CD-CPC-2025-00079 – Area Plan Amendment CD-CPC-2025-00077 – Rezoning CD-CPC-2025- 00076 – Development Plan

THE COLLECTION AT STALEY HILLS

July 16, 2025

City Plan Commission

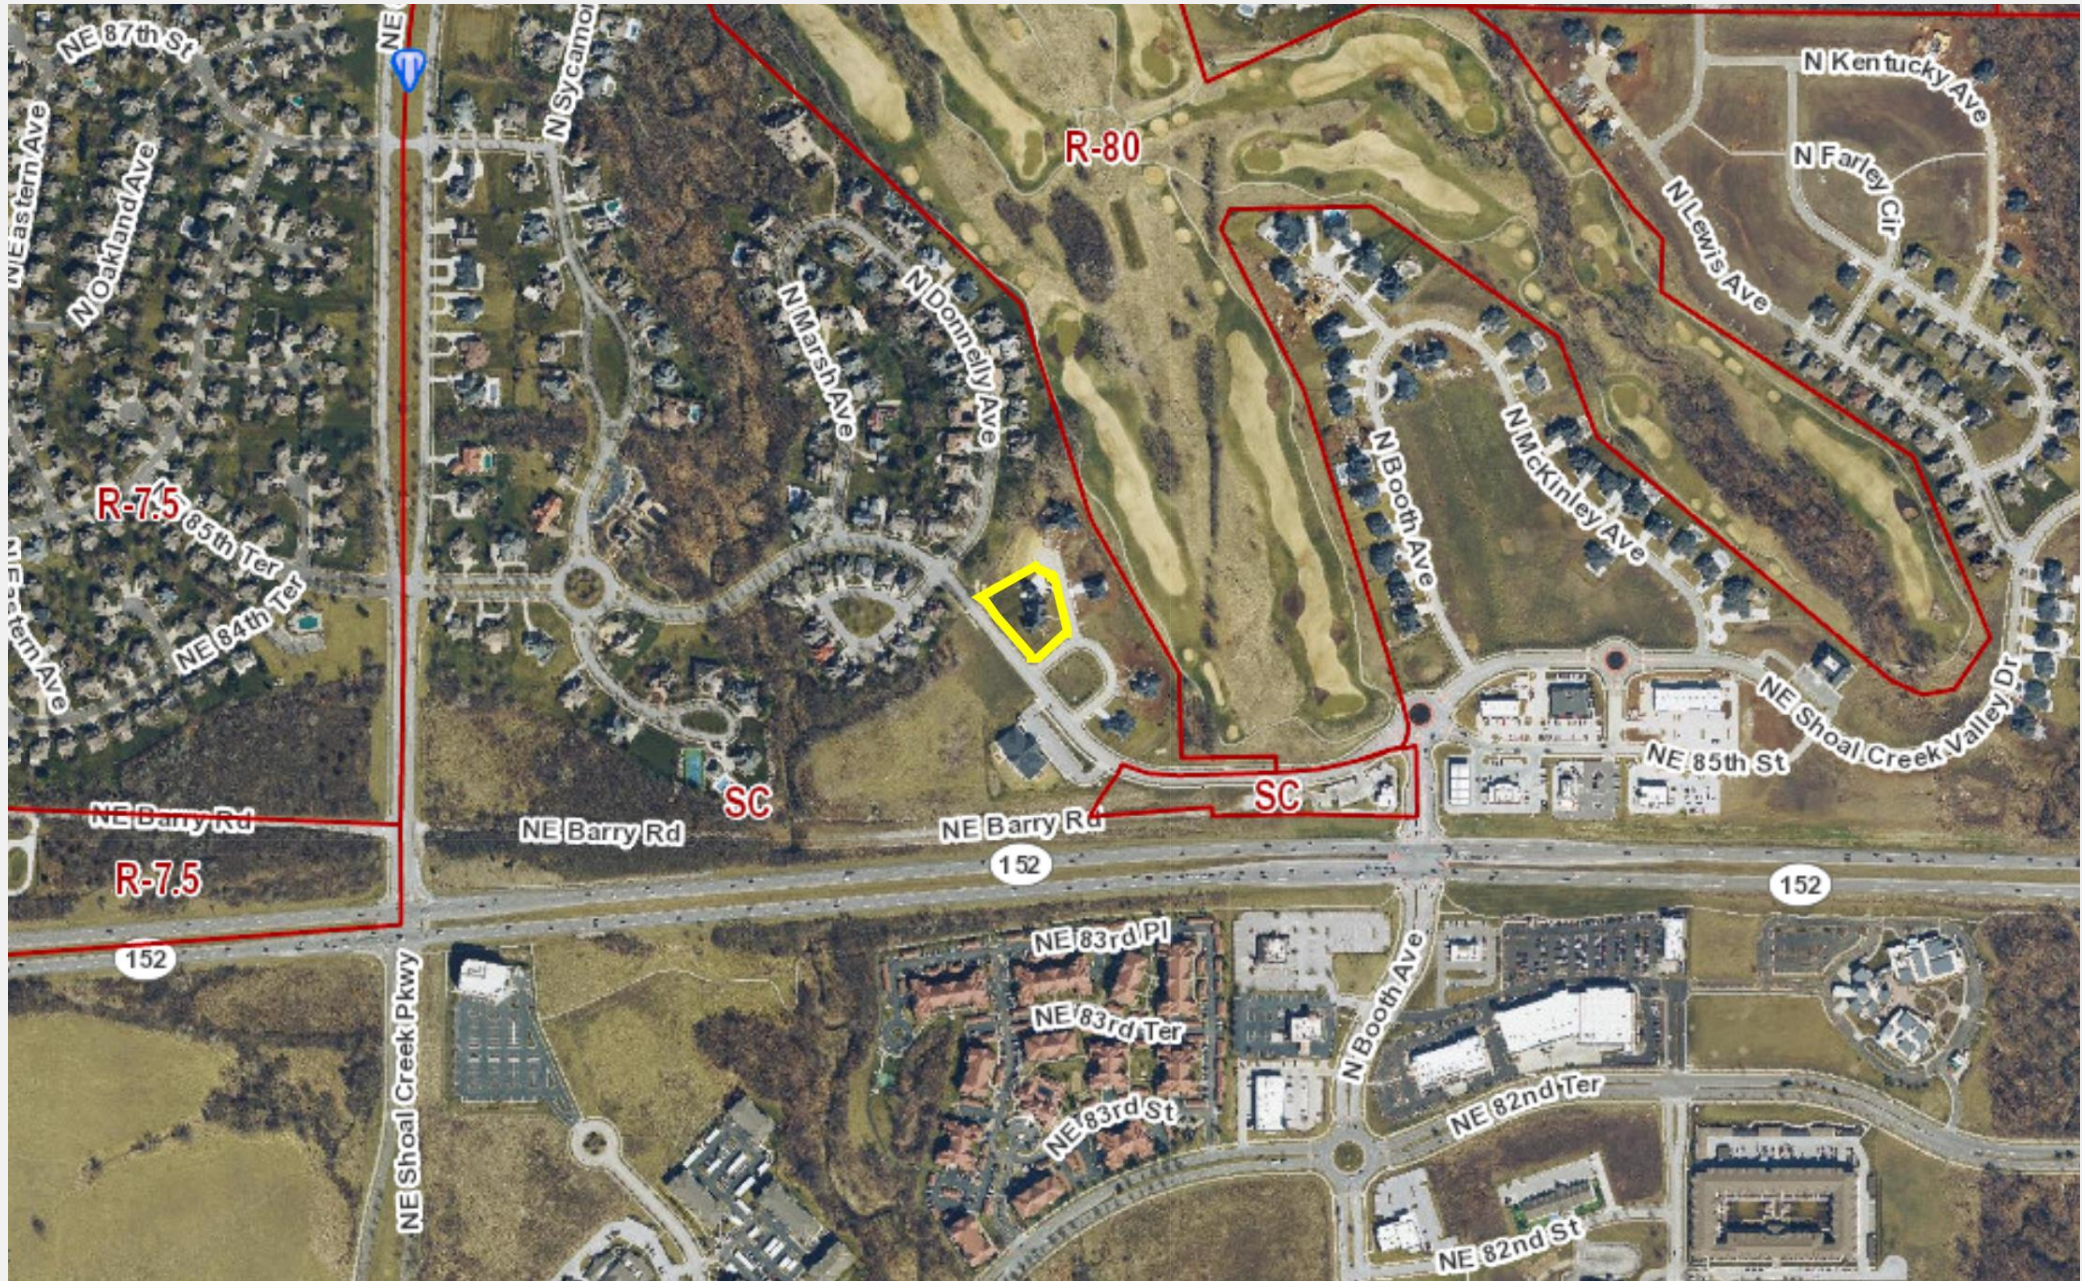
#22 Jeff Krebs agreed to revise the first sentence wording to: "Dumpster screening plans need to be submitted and reviewed with the Project Plan"

#27 The section of code needs to change from 88-232-01-A to 88-323-01-A

36 Kirk Rome said to change the wording to:

43 A Preliminary Stream Buffer Plan was submitted with the Development Plan. This comment needs to be removed.

"The developer shall submit water main extension plans for a new public fire hydrant along the south side of Shoal Creek Pkwy. The plans shall be reviewed and under contract (permit) prior to building permit issuance and prior to final plat recording."
